**Town of Kittery  
Planning Board Meeting  
January 11, 2024**

**ITEM 3 – 15 Bowen Road– Shoreland Development Plan Review**

Action: Accept application. Approve plan or continue review: Pursuant to §16.9.3 Shoreland Development Review of the Town of Kittery Land Use and Development Code, Nicole Sanborn, on behalf of owner/applicant Eric Dyer, requests approval to stabilize 86 linear feet of existing eroding shoreline with riprap along the property of 15 Bowen Road, Tax Map 17, Lot 4, in the Residential-Urban, Shoreland Overlay, and Resource Protection Overlay Zones.

SHORELINE STABILIZATION PLAN  
ON LAND LOCATED AT  
15 BOWEN ROAD  
KITTERY, YORK COUNTY, MAINE

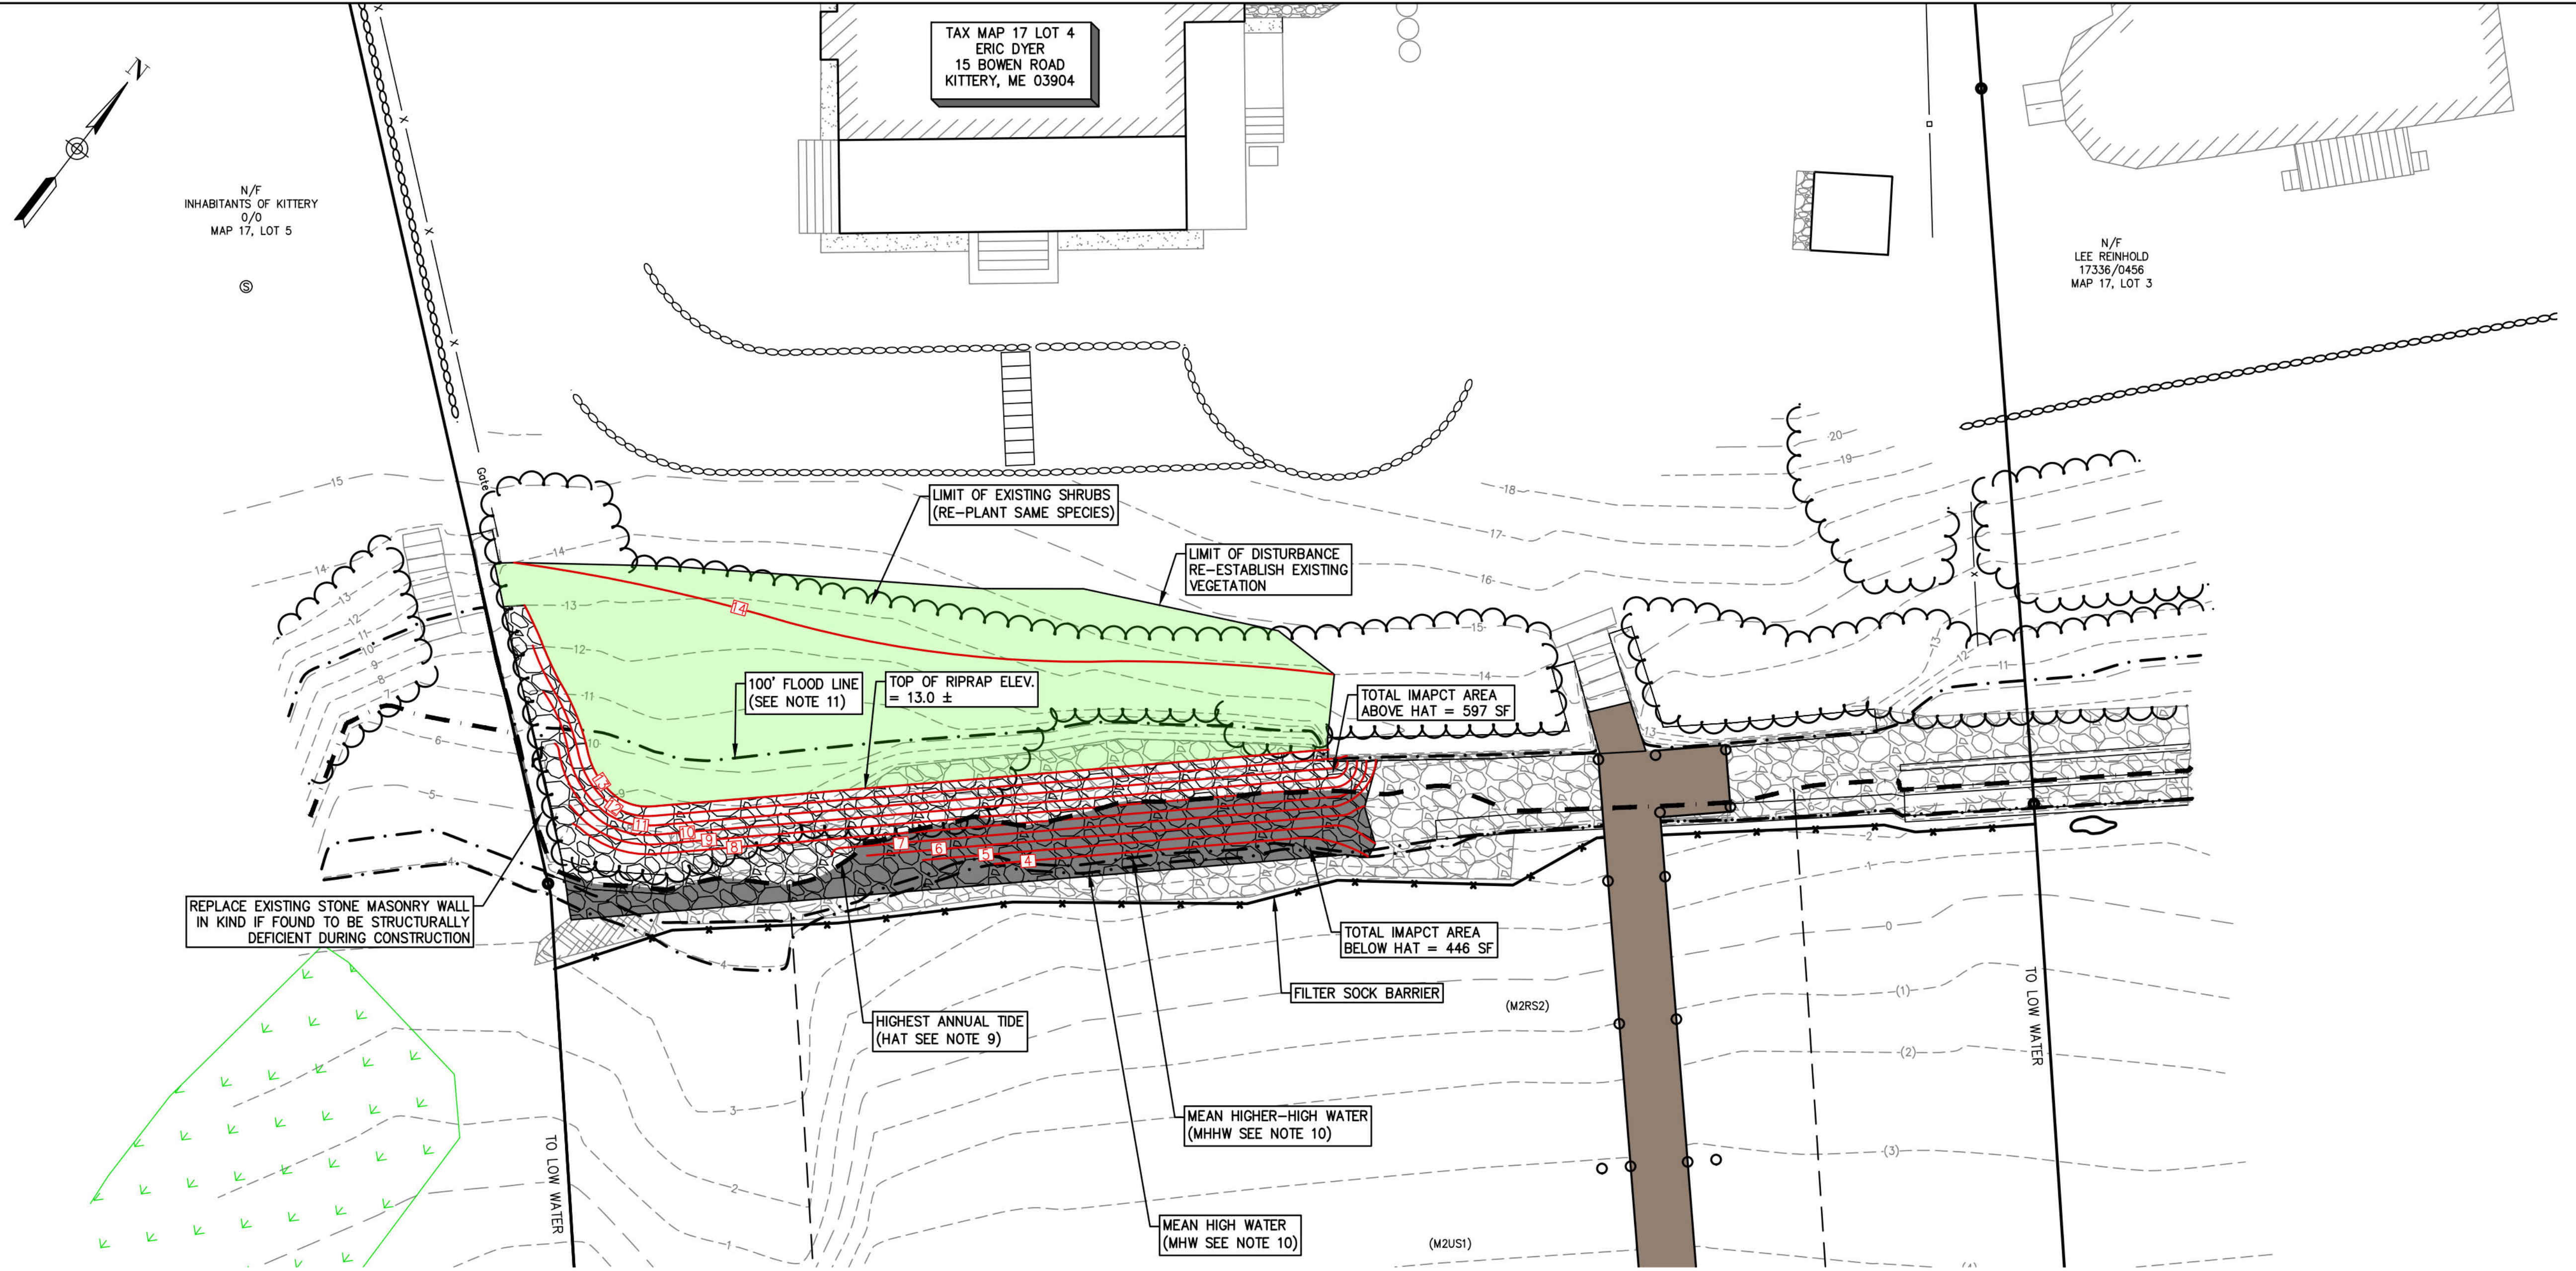
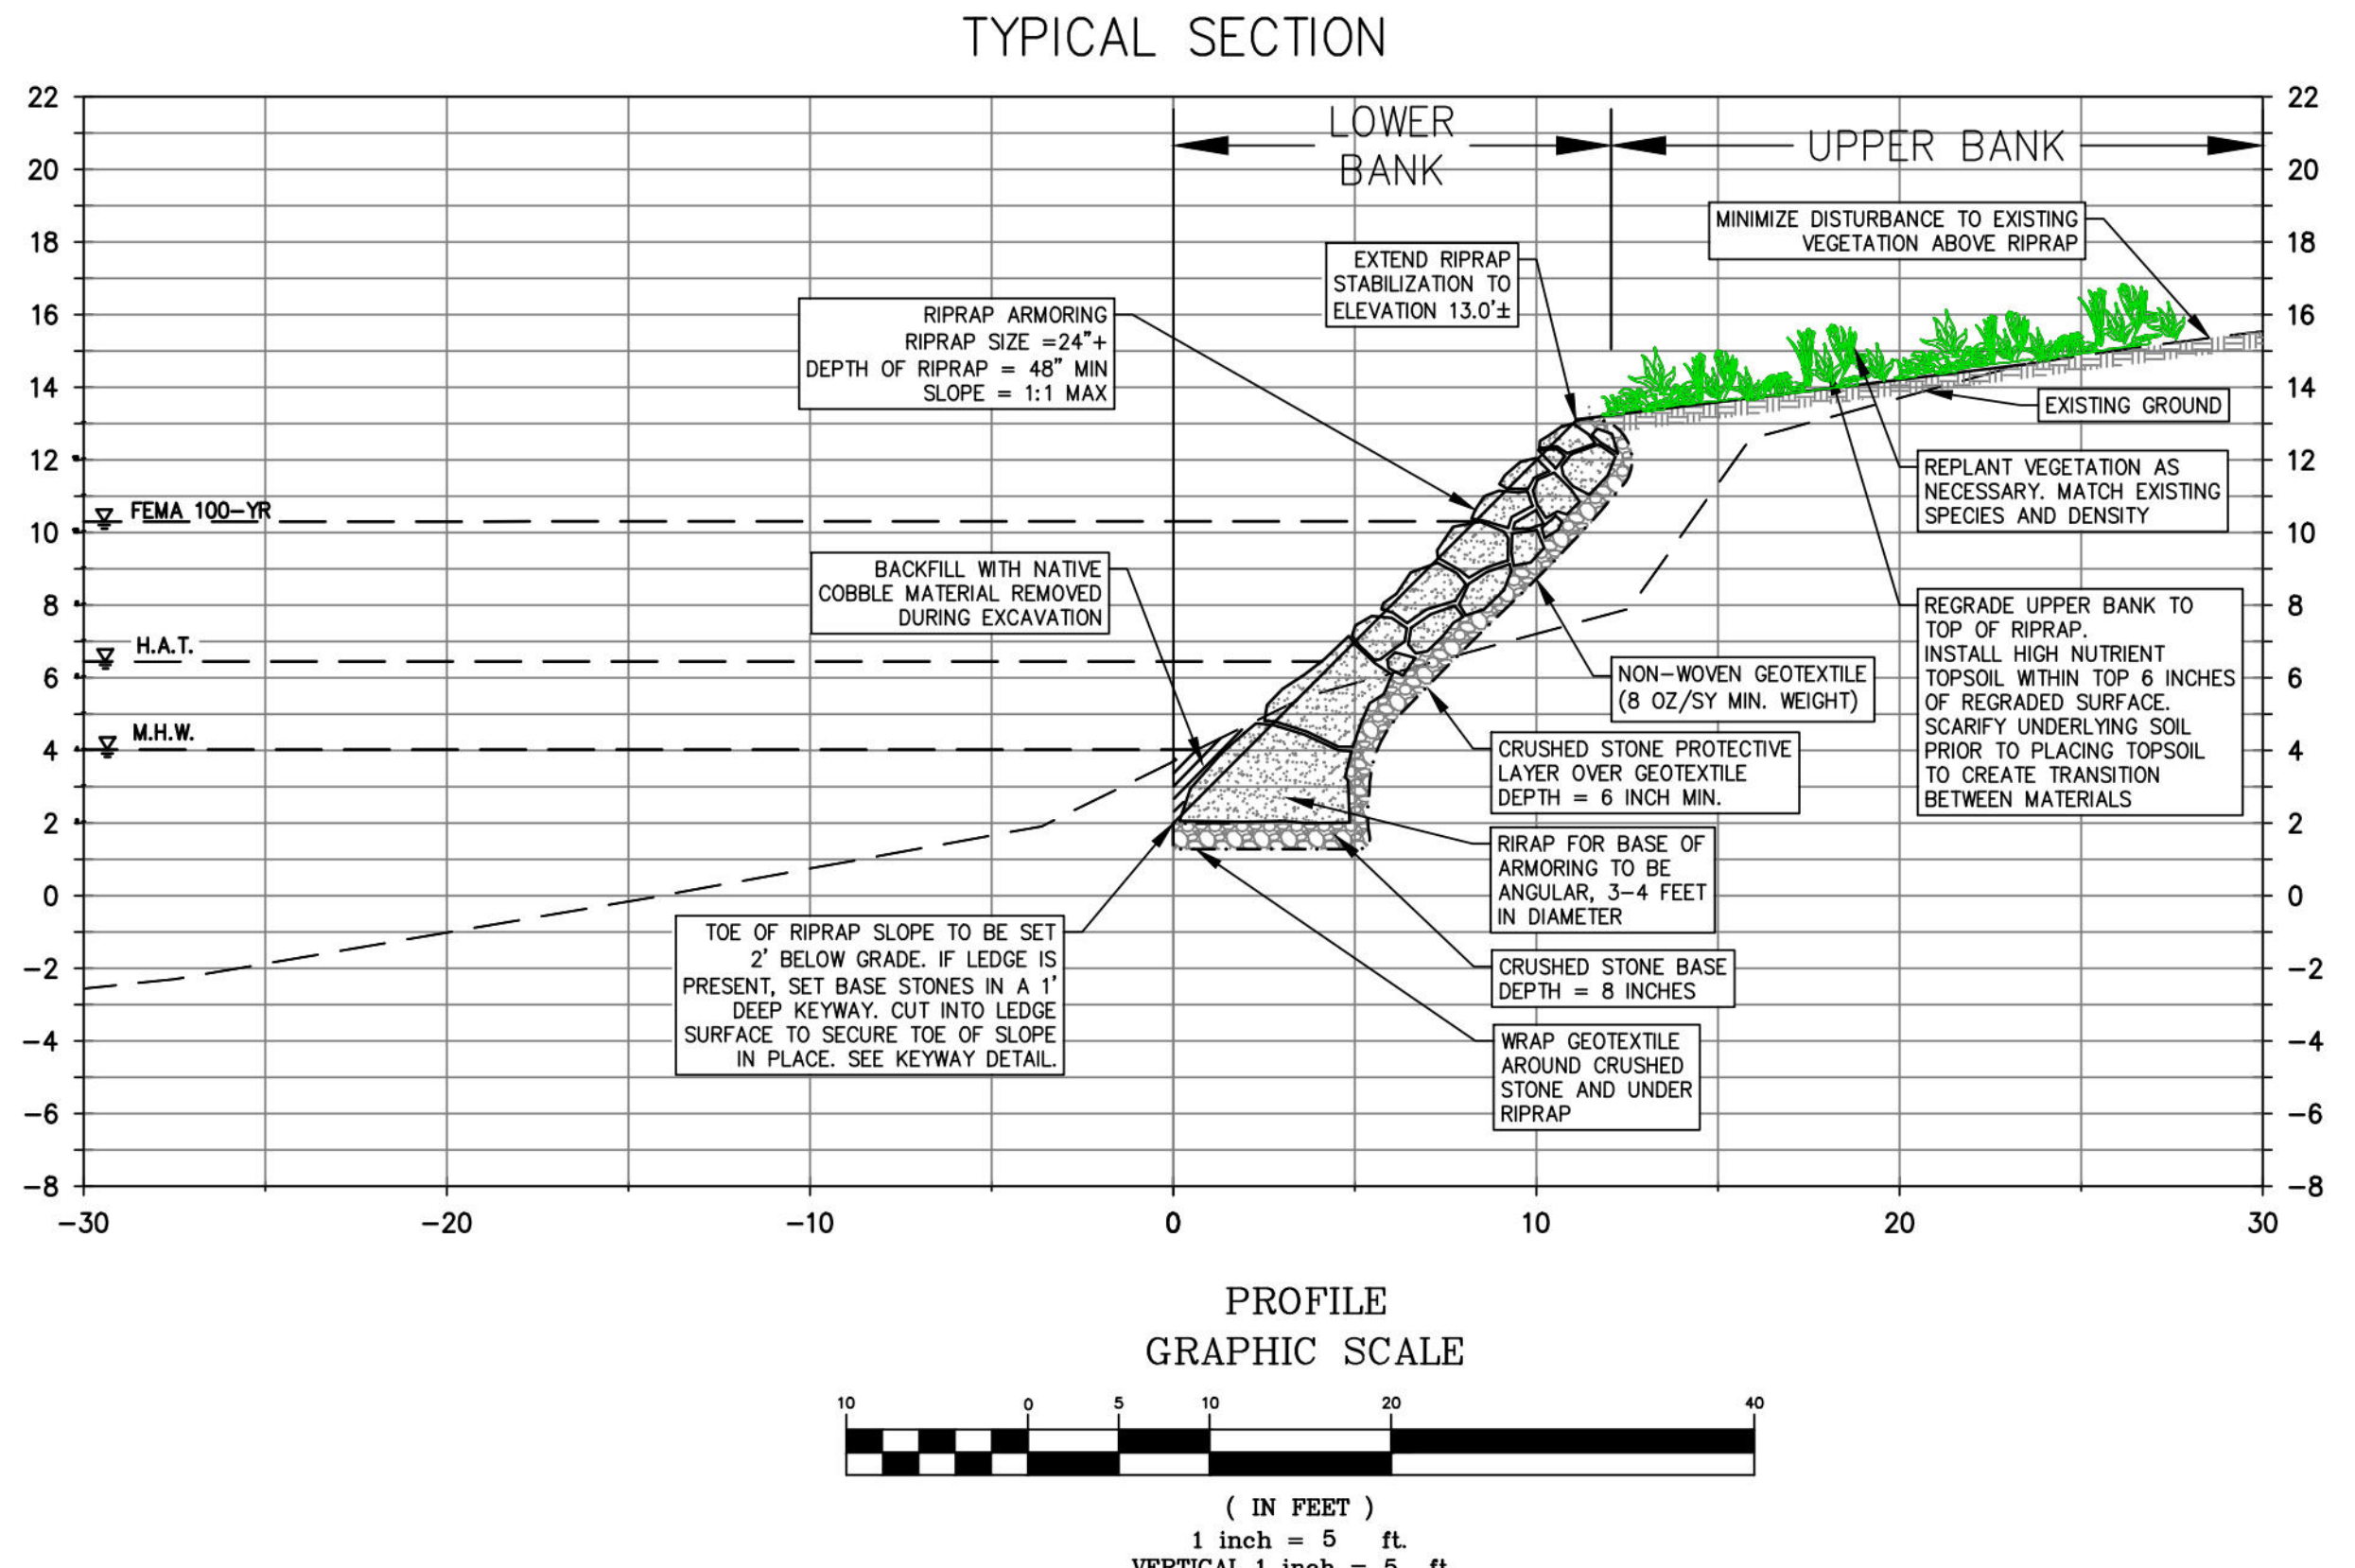
- 36 1. The survey has a note stating it will “replace an existing stone masonry wall in-kind if found to be  
37 structurally deficient during construction,” as the applicant does not want to disturb the wall unless  
38 necessary. To ensure compliance with all requirements, the applicant is seeking approval for the  
39 replacement of the wall during this meeting. Staff suggest a condition of approval stating that any  
40 replacement of the wall will be done in-kind, and maintain current height, width, and dimensions.

- 48 3. Attachment #6 contains the construction plans including a note confirming erosion control methods  
49 will be in place before work may begin.
- 50 4. The Shoreland Overlay Zone Ordinance §16.4.28.E.(3).(a). requires new principal and accessory  
51 structures to be set back at least 100 feet, horizontal distance, from the HAT line of any water  
52 bodies, tributary streams, the upland edge of a coastal wetland, or the upland edge of a freshwater  
53 wetlands. Shoreland stabilization is not considered a structure in regards to this setback.

- 56 5. §16.4.28.E.(2). allows 20% of total lot area in the shoreland zoning overlay to be comprised of  
57 non-vegetated surfaces or structures. The applicant has provided an email from Jeffrey Kalinich at  
58 Maine Department of Environmental Protection confirming that land used for shoreline  
59 stabilization projects are exempt from devegetation calculations. Because the project proposes only  
60 shoreline stabilization, devegetation calculations are not required.

- 61 a. Staff suggest a condition of approval to be added to the plan noting that all future  
62 development not related to shoreline stabilization must include the entire riprap area in  
63 devegetation calculations.

1. All future developments not related to shoreline stabilization must include the entire riprap area in revegetation calculations.
2. Any replacement of the stone wall between 15 Bowen Road and the adjacent southwest property must be done in-kind, maintaining current dimensions, or else seek subsequent planning board approval.
3. Without prior approval, no changes, erasures, modifications or revisions may be made to any Planning Board approved final plan per Title 16.9.3.I.
